MANAGEMENT REPORT AND RECOMMENDATION
IN RESPONSE TO THE
INSPECTION PANEL INVESTIGATION REPORT

Private Power Generation (Bujagali) Project
(IDA Guarantee No. B0130-UG)

November 7, 2008

Figure 1. Lake Victoria Level in the Case of Low Release – Low Hydrology Scenario (Reference Period 60 years from 1900 to 1959)

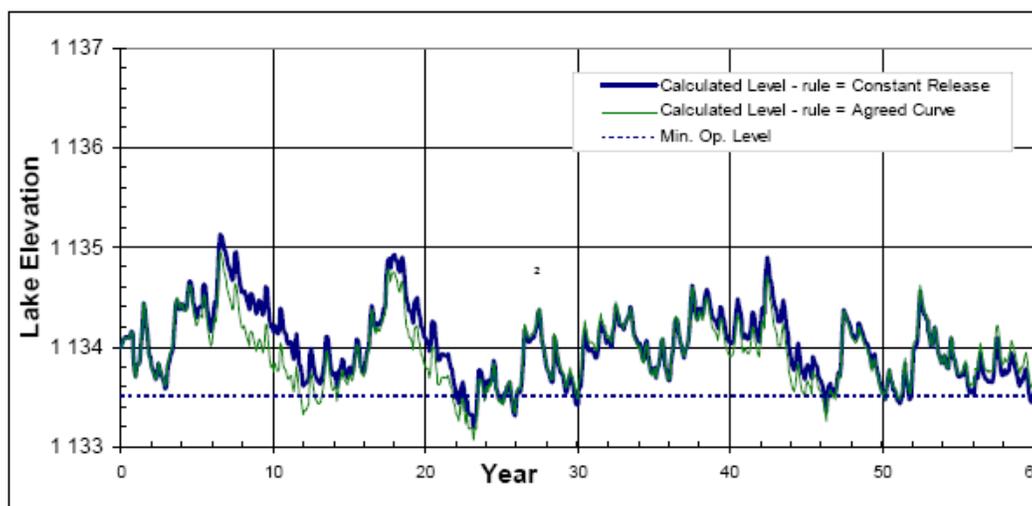
Management reiterates that the “Constant Release” is used only as a simplifying analytical tool and neither the Government nor the Bank has advocated the use of “Constant Release” instead of the Agreed Curve regime.
